STAFF REPORT
KETCHUM PLANNING AND ZONING COMMISSION
SPECIAL MEETING ON SEPTEMBER 27, 2022

PROJECT: McGavick Residence

FILE NUMBER: P22-048

APPLICATION: Pre-Application Mountain Overlay Design Review

Figure 3: Ridgeline Reference Diagram (points referenced for Images in Attachment D)

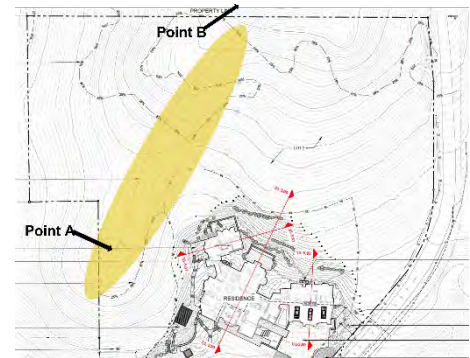
During the department review period, staff conducted an extensive site visit to verify not only the location of the story poles, but whether the structure would be visible from various vantage points including 4th Street and East Ave and locations south of the property as noted on Figure 4. The red star is the location of the subject property. The yellow stars indicate vantage points where staff made observations to determine if the building would be visible above the ridgeline. As shown in the figures in Attachment D, the proposed project would not be visible above the ridgeline from these locations, nor would the proposed project be visible from the identified vantage points due to the topography and extensive tree canopy surrounding the property.

**SITE GRADING +
DRAINAGE PLAN**

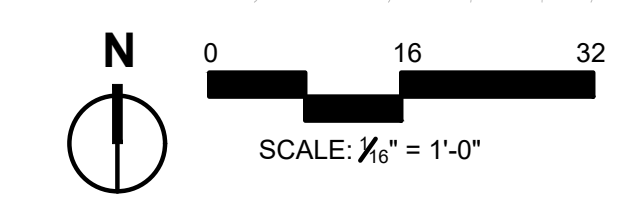
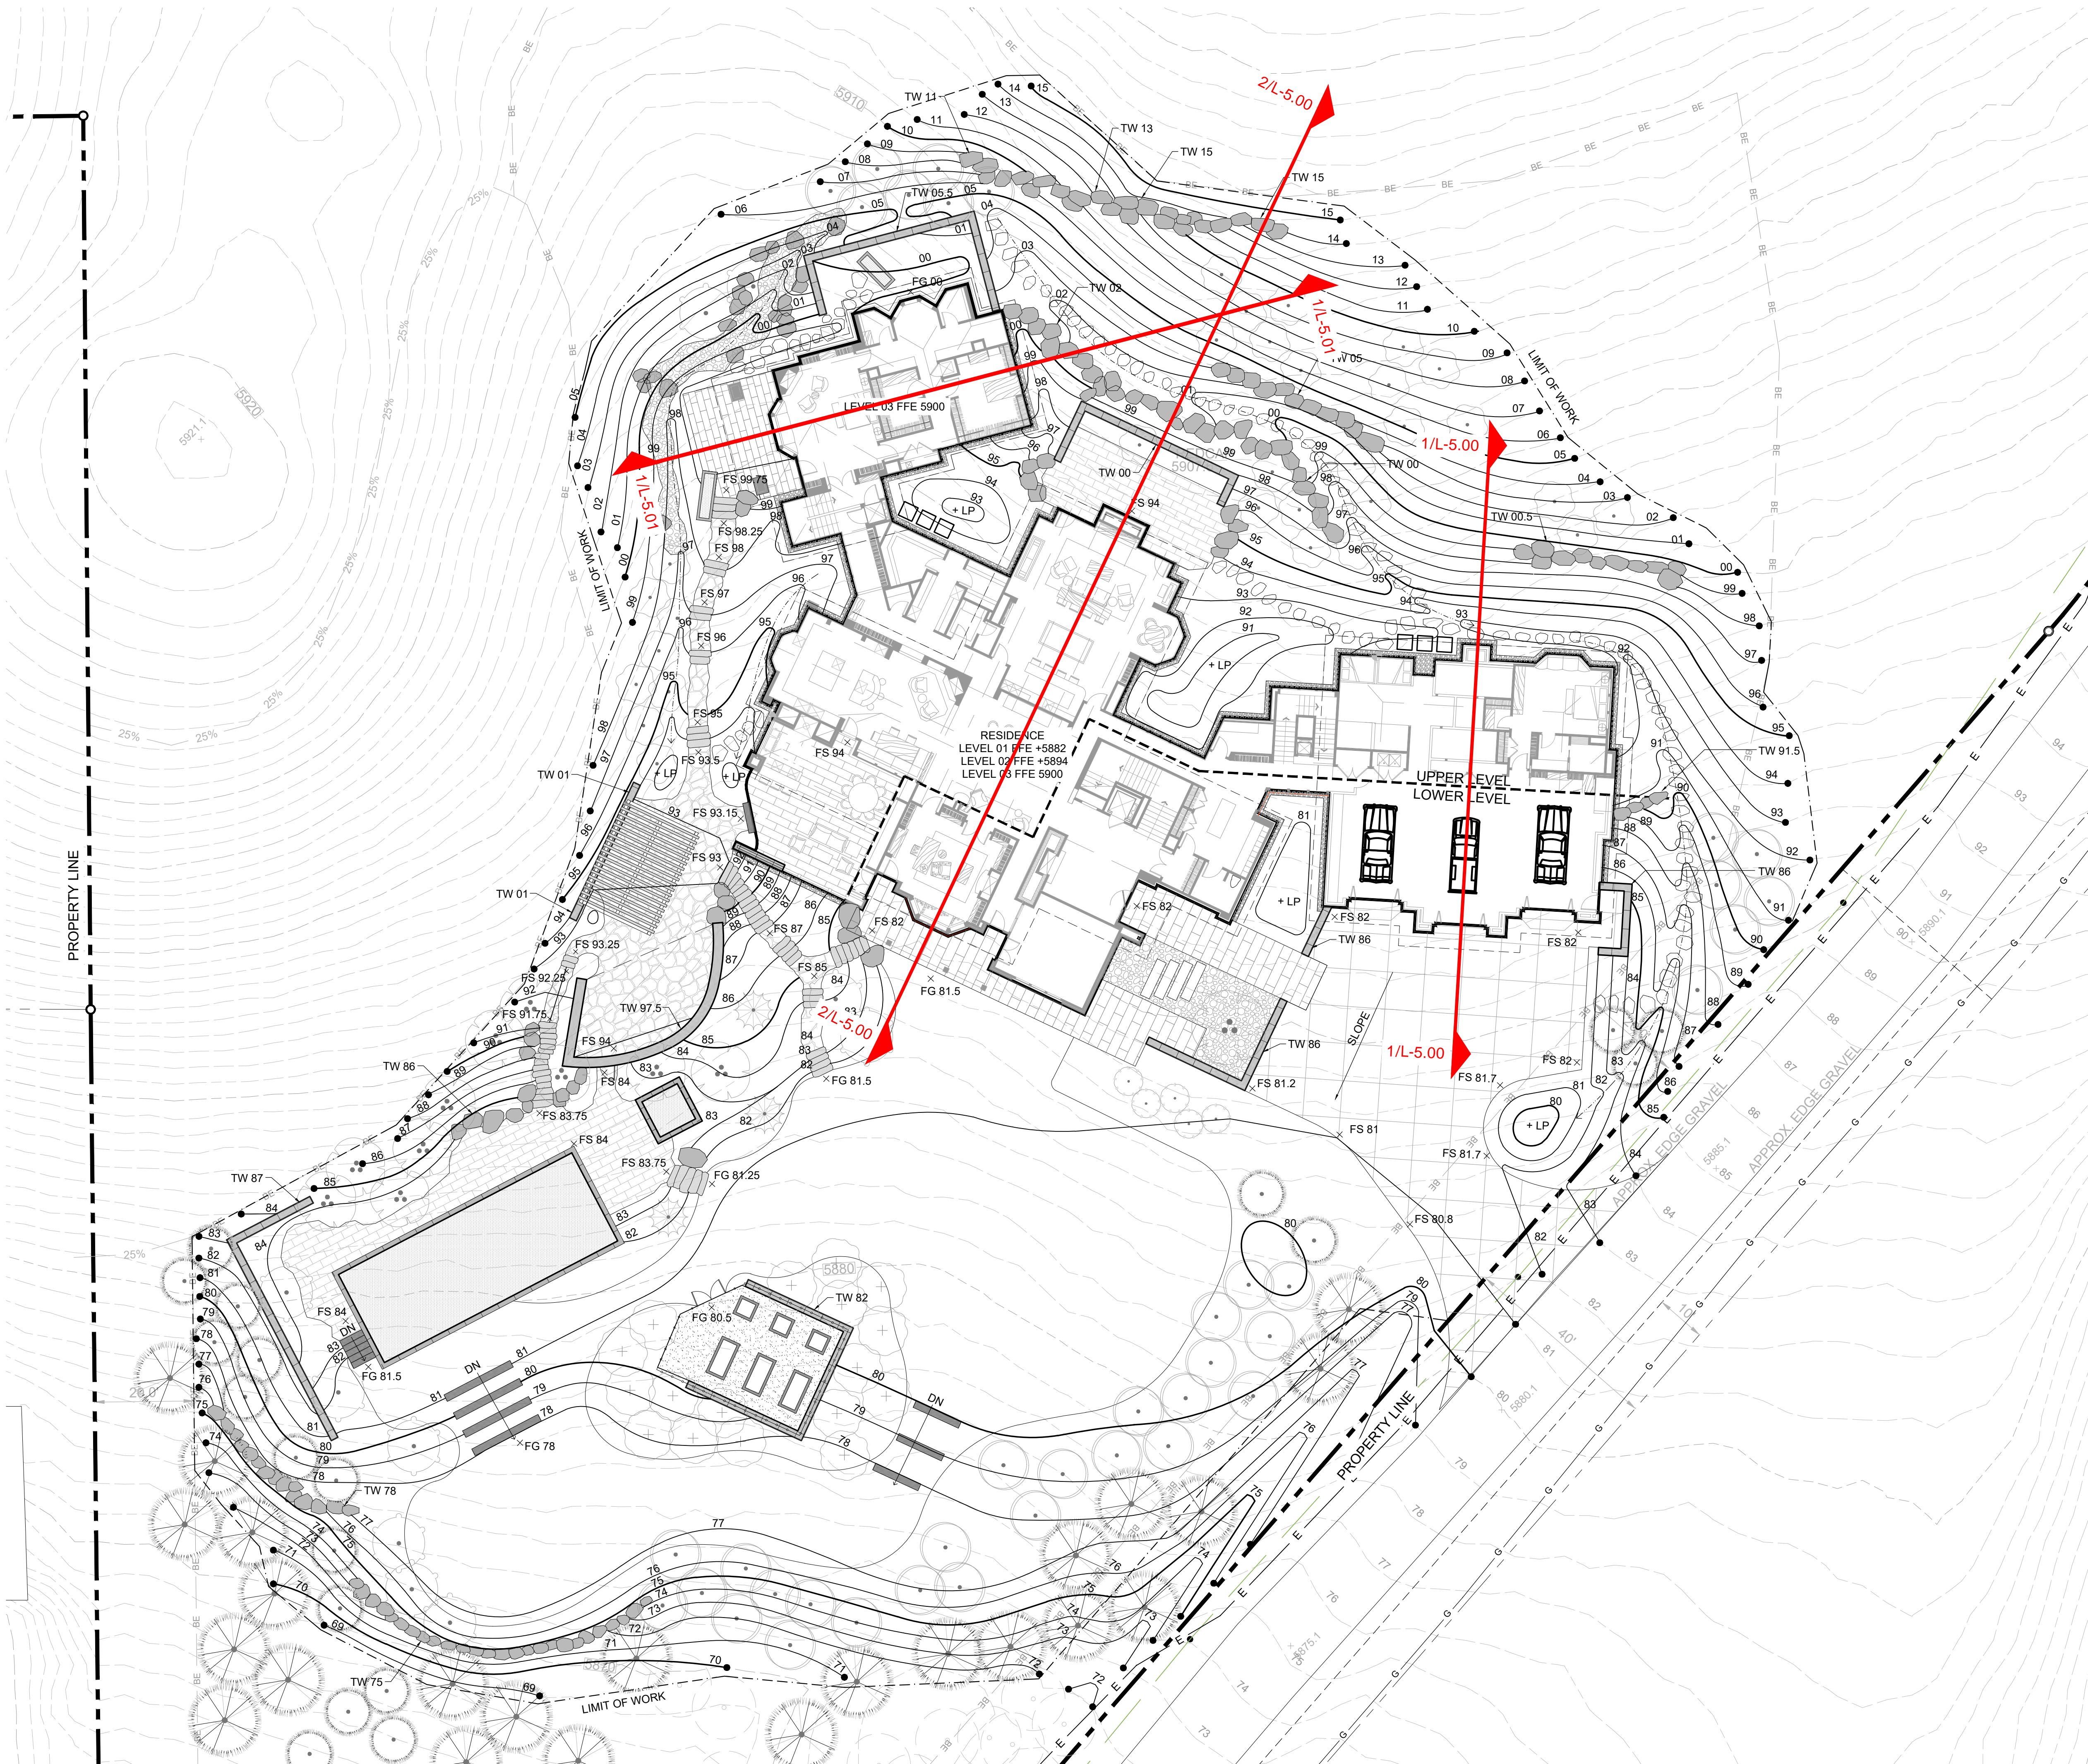
Pursuant to KMC §17.96.060.C1 and 17.124.170.A.1, all stormwater must be retained on site. The project plans include a grading and drainage plan; however, the proposed drainage funnels all stormwater along a newly created drainage swale along the private drive, south and off the property. This current configuration does not meet the city standards for retaining stormwater and will need to be addressed for the final design review application. The applicant is aware of this issue and will comply with the requirements as outlined in the KMC.

The proposed drainage also increases the amount of disturbance outside the building envelope. Per plat note 4 "All existing vegetation outside of building envelopes shall be preserved (with exception of driveway connections from the access road and livestock grazing as pursuant to Note 5)." As proposed all stormwater is being funneled from the top of the property into one main drainage channel along the private driveway, requiring the removal of existing shrubs and tall grass vegetation for the length of the building envelope. Disturbance is permitted for the driveway connection, however, disturbance not related to the driveway should be avoided. The applicant is aware of this issue and will evaluate alternative drainage solutions for review during final design review.

SITE PLANTING PLAN

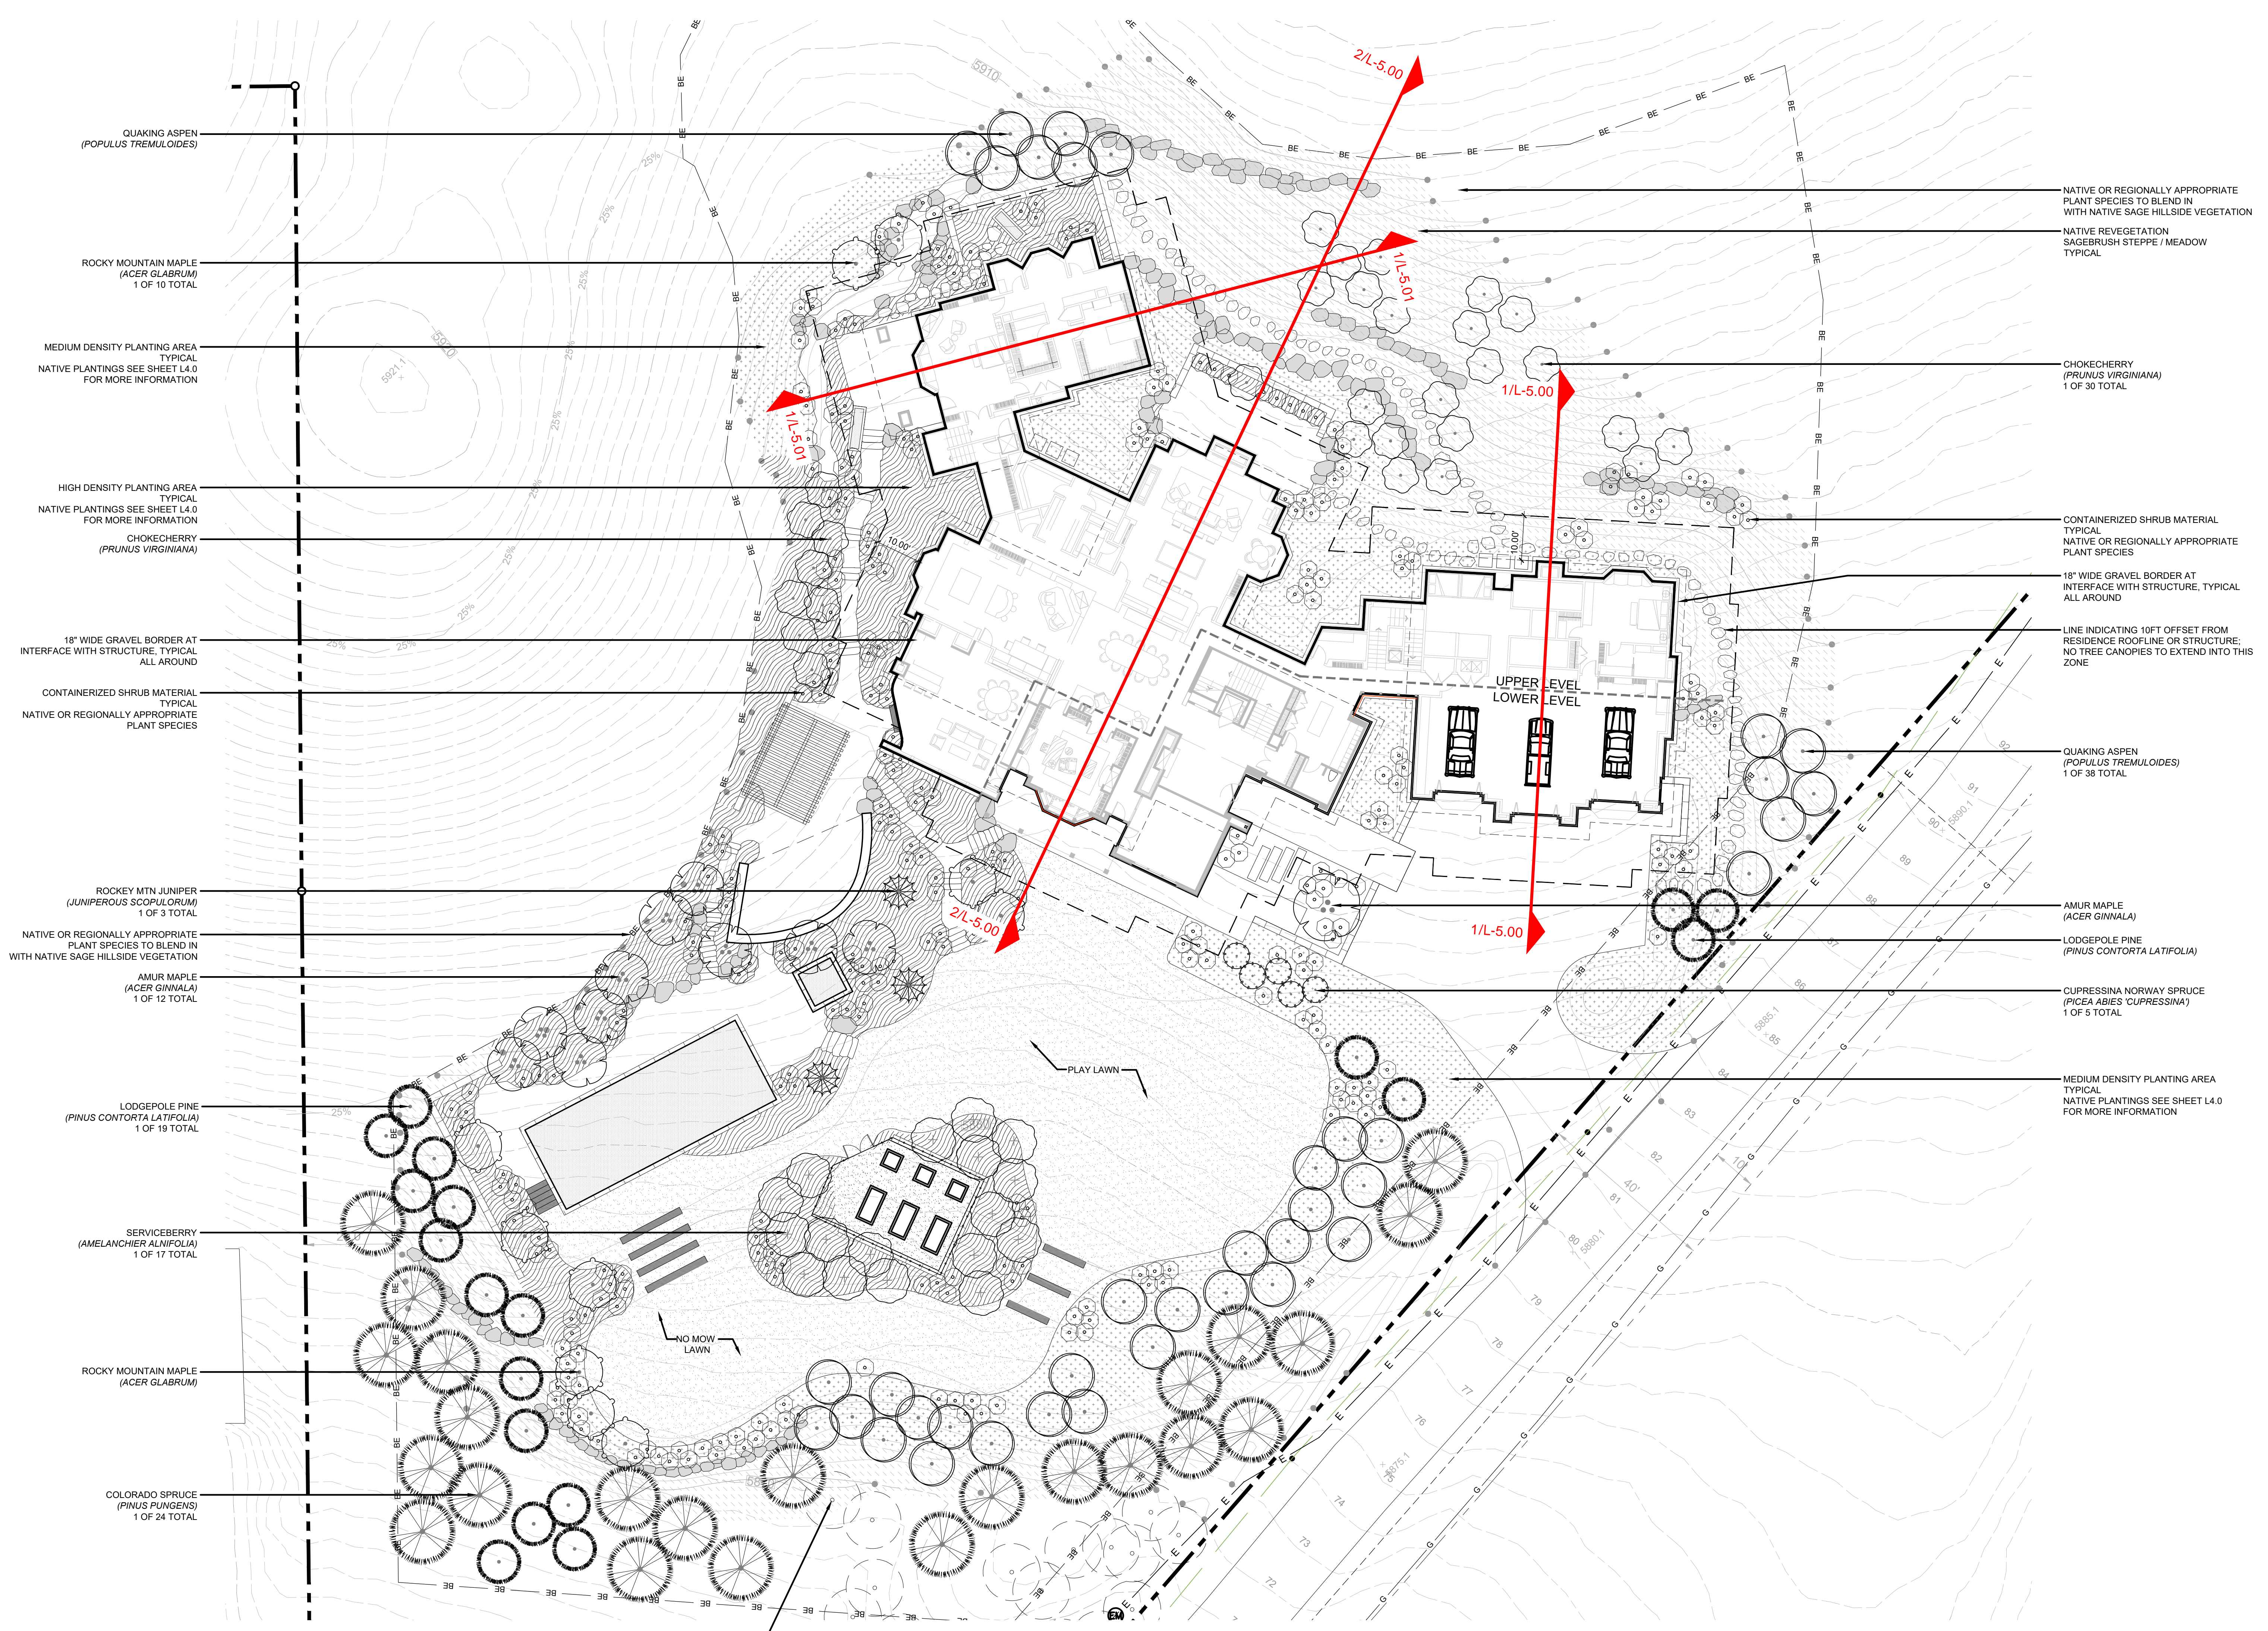
KMC Section 17.104.070A.9 states that "Cuts and fills allowed for roadways shall be minimized; lengths of driveways allowed shall be minimized; all cuts and fills shall be concealed with landscaping, revegetation and/or natural stone materials. Revegetation on hillsides with a clear zone of thirty feet (30') around all structures is recommended. Said clear zone shall include low combustible irrigated vegetation with appropriate species, on file with the Ketchum planning department. Revegetation outside of this clear zone should be harmonious with the surrounding hillsides." This standard is primarily focused on prevention of structure damage in the event of a wildfire; however, the last sentence is of specific note related to the type of vegetation that should be outside the clear zone. As shown on Sheet L4.01, the proposed project is meeting minimum fire code requirements of a 10-foot clear zone, however, adjustments to the planting plan would be required if the Commission felt a 30-foot clear zone was necessary. Additionally, there is significant landscaping that does not blend with the surrounding hillsides, which is primarily sage brush, tall grasses and other drought tolerant species. The proposed landscape plan includes extensive tree plantings,

decorative shrubs, a play lawn, and a no mow lawn. Other than landscaping down the hill in the more developed area of Garnet Street, these landscaping choices are not found with the surrounding hillsides.
